Subject: TIB 59-002 Holland FW17 Series Fifth Wheel Release Handles Remain in the Unlocked Position
This notice applies to your vehicle; VIN

Technical Information Bulletin

59-002

Holland FW17 Series Fifth Wheel Release Handles Remain in Unlocked Position

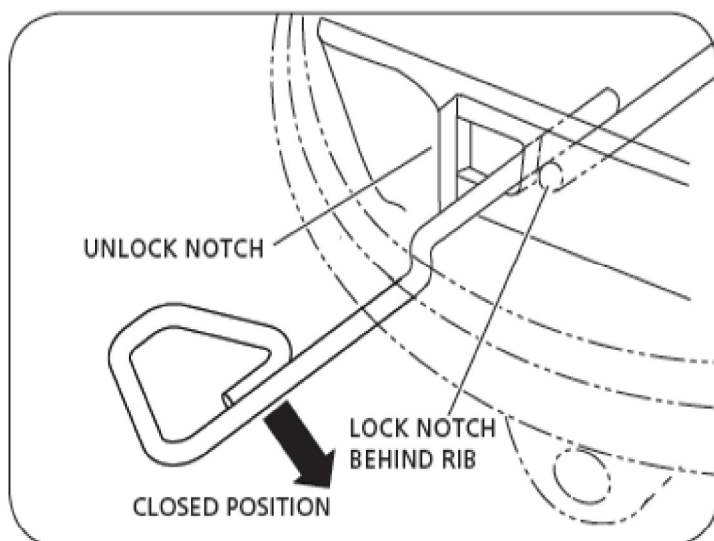
Peterbilt has been notified by Holland that certain vehicle Models 365, 367, 567, 579, 389 and 389G glider kits built between January 18, 2018 and October 23, 2018 were manufactured with a Holland FW17 series fifth wheel with a release handle that may not lock properly. [The lock notch of the manual release handle may get stuck on the rib window when moving from the hooked open, ready to uncouple position to the ready to couple position.](#) When the vehicle operator attempts to couple the fifth wheel to the next trailer kingpin of a parked trailer, the fifth wheel lock will not engage the hook resulting in an open position instead of a fully locked position. This is visually detectable by the vehicle operator via the fifth wheel handle position. [Vehicle fifth wheel to trailer king pin coupling is legally required to be visually inspected per FMSCR 392.7.](#) This potential issue does not affect locked fifth wheel performance; if the fifth wheel were locked and manual release handle in the proper IN position, the fifth wheel will not unintentionally uncouple. **This repair is for manual release fifth wheels only.**

See figure below showing the lock/unlock notch and rib window where the handle goes [through](#).

1. Review the attached chassis list for your dealer code and schedule your customer(s) for service if their chassis is on the list.
2. If you are not using SmartLINQ Service Management to start repair orders, review the DWWC or SIR for "Complete" next to the "59002" campaign code prior to performing this repair.
3. Follow the procedures below to inspect and if required, install a new release handle.
